# APPLICATION FOR APPEAL

Number & Street: 1451 Clarence St. City: St. Paul State: MN Zip: 55106

### FIRE INSPECTION CORRECTION NOTICE

RE: 1449 CLARENCE ST  
Ref. #111289  
Residential Class: B

1451 Clarence

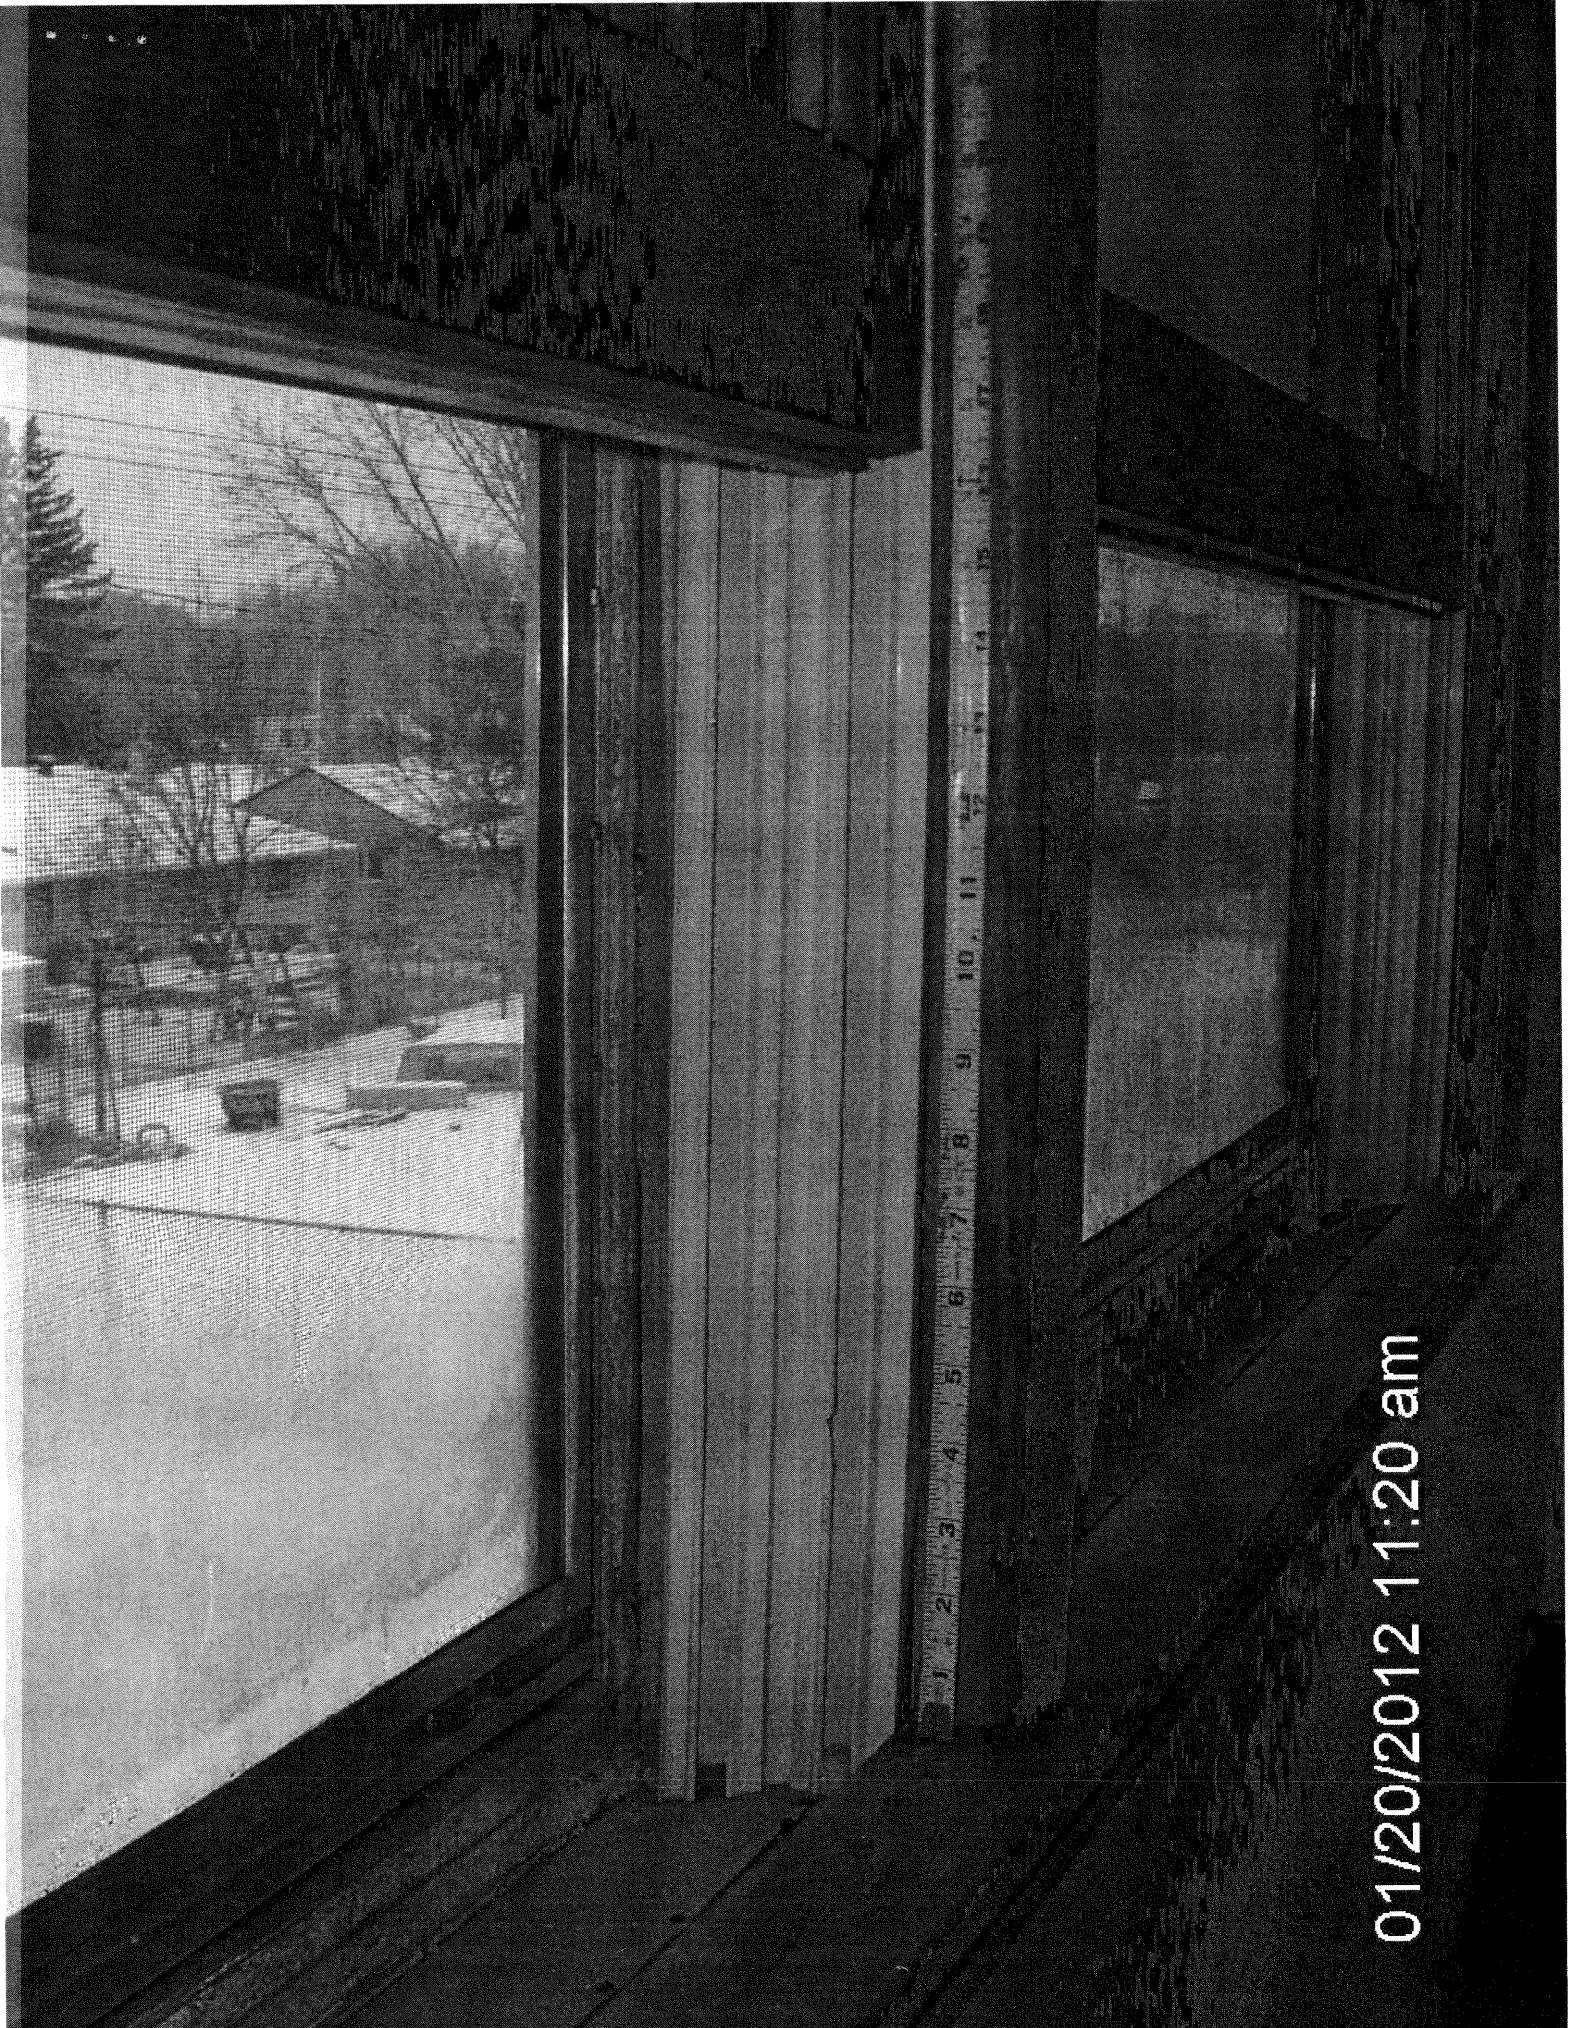
#5 1451 Bedroom S.W Side - MSFC 1026.1  
Request variance on openable height.

5. 1451 Bedroom S.W Side - MSFC1026.1 - Provide and maintain an approved escape window from each sleeping room. The minimum size must be 5 square feet of glazed area with a minimum of 24 inches of openable height and 20 inches of openable width. With a finished sill height not more than 48 inches. This work may require permit(s). Call DSI at (651)- 266-9090. Refer to the Escape Windows for Residential Occupancies handout for more information. -Double hung windows . Openable height is 14inches . Openable width is 38 inches. Sill 44inches. Glazed 30inches in height by 35inches in width.
